Access Compliance Report Public Rights-of-Way (Curb Ramps)

Main Street: MONROE_ST Cross Street: WORTHY_DR Location: NE

ADA ID: RPRK210930123815 Ramp Type: Type 1 - Perpendicular Diagonal Initial Pass/Fail: Fail Overall Compliance: No Severity Score: 15

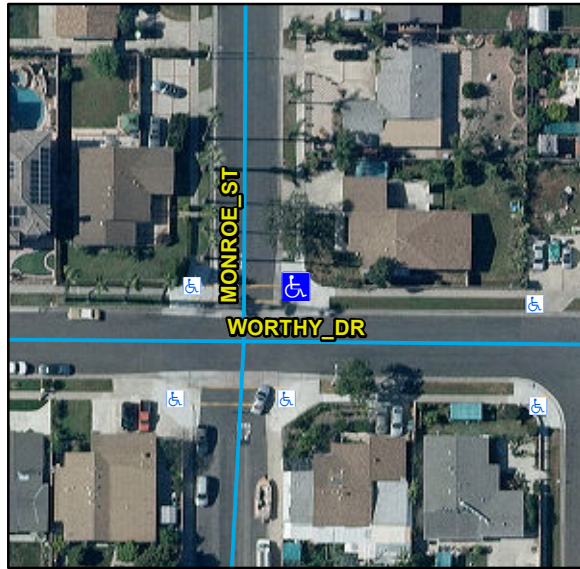
Compliance	Description	Data	Compliance	Description	Data
N/A	Ramp Length (in)	127	N/A	Flare Type LT	
Yes	Ramp Width (in)	48			N/A
No	Ramp Run Slope (%)	9.1	N/A	Flare Slope LT (%)	N/A
Yes	Ramp Cross Slope (%)	0.8	N/A	Flare Traversable LT	N/A
N/A	Landing Present	N/A	N/A	Flare Type RT	
N/A	Landing Length (in)	N/A			N/A
N/A	Landing Width (in)	N/A	N/A	Flare Slope RT (%)	N/A
N/A	Landing Run Slope (%)	N/A	N/A	Flare Traversable RT	N/A
N/A	Landing Cross Slope (%)	N/A	N/A	DWS Provided	N/A
N/A	Landing Movement Obstructed?	N/A	N/A	DWS Contrast	N/A
	Landing Movement Type	N/A	N/A	DWS Length (in)	N/A
N/A	Landing Shared	N/A	N/A	DWS Full Width	N/A
N/A	Clear Space	Yes	N/A	DWS Offset Left (in)	N/A
N/A	Clear Space To Crosswalk (in)	N/A	N/A	DWS Offset Right (in)	N/A
N/A	Marked Crosswalk 1	Yes	N/A	Marked Crosswalk 2	No
	Crossing 1 Direction	W		Crossing 2 Direction	S
	Marked Crosswalk 1 Width (in)	112		Marked Crosswalk 2 Width (in)	N/A

N/A	Ramp Inside Crosswalk 1	No	Yes	Ramp Inside Crosswalk 2	N/A
	Crossing 1 Slope (%)	5.6		Crossing 2 Slope (%)	2.7
	Crossing 1 Cross Slope (%)	2.7		Crossing 2 Cross Slope (%)	1.1
N/A	Gutter Ponding	N/A	No	Curb Slope	6.4
Yes	Gutter Lip Height (in)	0		Road Run Slope (%)	2
N/A	Gutter Run Slope (%)	N/A		Road Cross Slope (%)	4.7
N/A	Gutter Cross Slope (%)	N/A			
Yes	Overall Surface Condition: Acceptable		Yes	Perp Joint Present	Yes
	Cross Gutter Present?	Yes		Spandrel Present?	Yes
	Replace Cross Gutter?	No		Replace Spandrel?	No

Remove & Replace Curb Ramp With Two New Directional Ramps or Equivalent. Restripe Crosswalk.

R304.2.2, STD 1115
